2013 Design Update Training

Structures Related 2013 Design Standards

Current Significant Revisions to Design Standards

Design Standards 2013

CONCRETE BOX CULVERT DETAILS (LRFD)

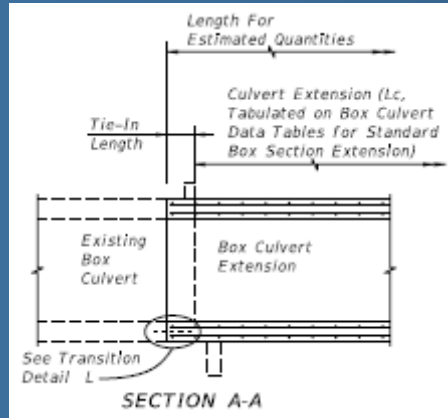
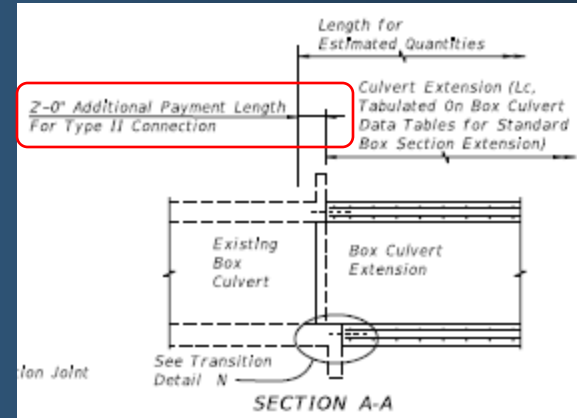
Added note to Data Table (Cell) to clarify Payment includes 2 ft. additional payment length.

Reasoning:

- Type 1 connection will typically be allowed as an option for all projects.
- MathCAD Design Program calculates quantities based on Type 1 connection and generates the quantities for importing into the Data Table.
- Contractor's bids will be consistent.

TRAFFIC RAILING (THRIE BEAM RETROFIT)

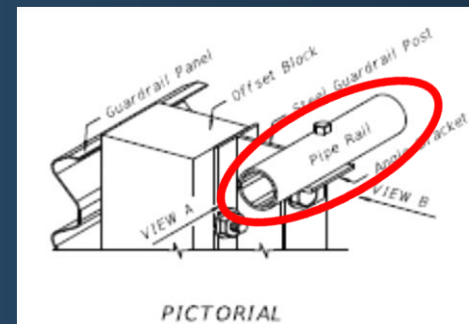
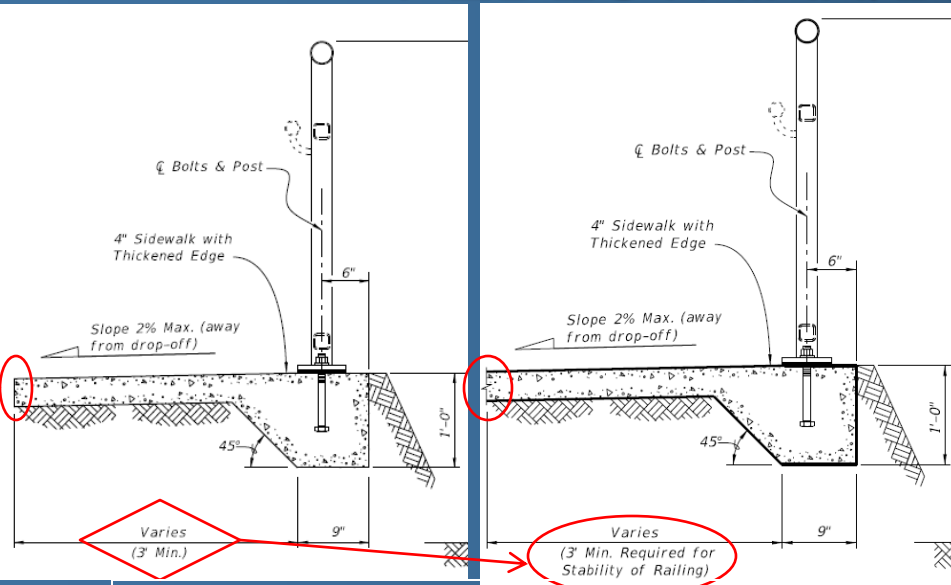
Removed "Pedestrian Safety Treatments"; Now paid for directly per linear foot as in Index 400.

PEDESTRIAN/BICYCLE RAILING

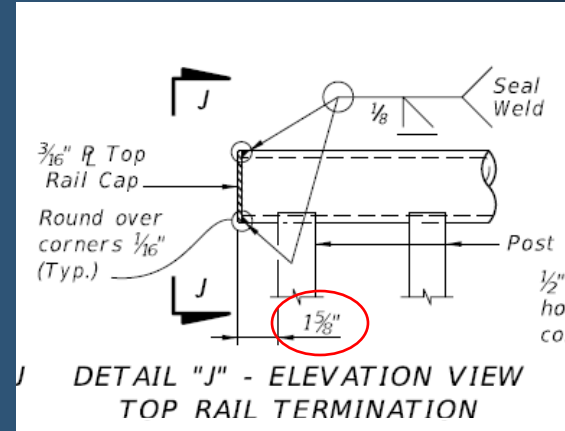
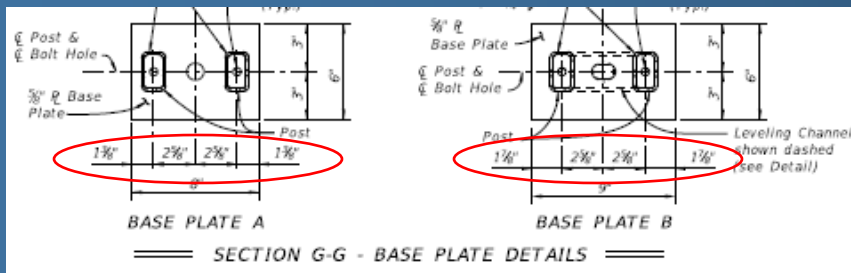
BOE has been updated to clarify validity of Rail Types – See new Section 515-2

For projects with letting dates of October 2012 and later, correct the Plans and Comp Book with the valid Pay Item numbers for Indexes 852 & 862.

Index 20000 Series & 20200 Series FIBs & FUBs (FIBs Shown, FUBs similar)

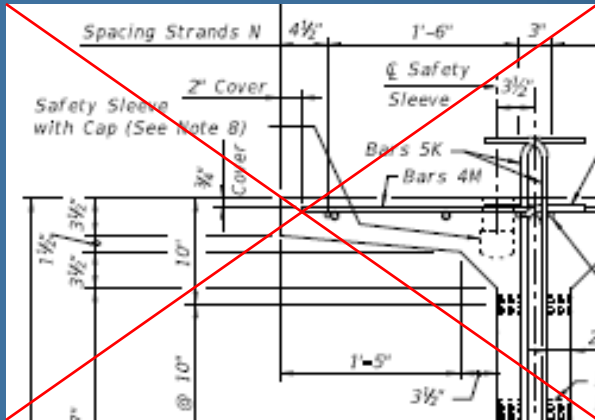
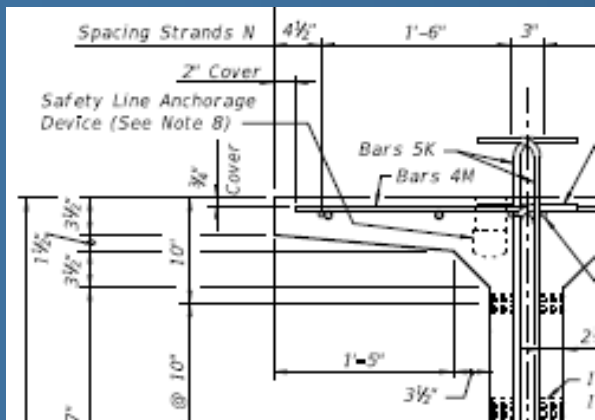
~~8. Safety Sleeves or other Safety Line Anchorage Devices are permitted in the top flange. One Safety Sleeve alternative is provided herein as 2 1/4" NPS x 5" Sch. 40 PVC Pipe with Cap installed 2'-0" from ends of beams and spaced on 8'-0" (Max.) centers. Holes shall be free of debris and water prior to casting deck.~~

OLD

NEW

8. Safety Line Anchorage Devices or sleeves are required and permitted in the top flange only to accommodate fall protection systems used during construction. See shop drawings for details and spacing of any required embedments.
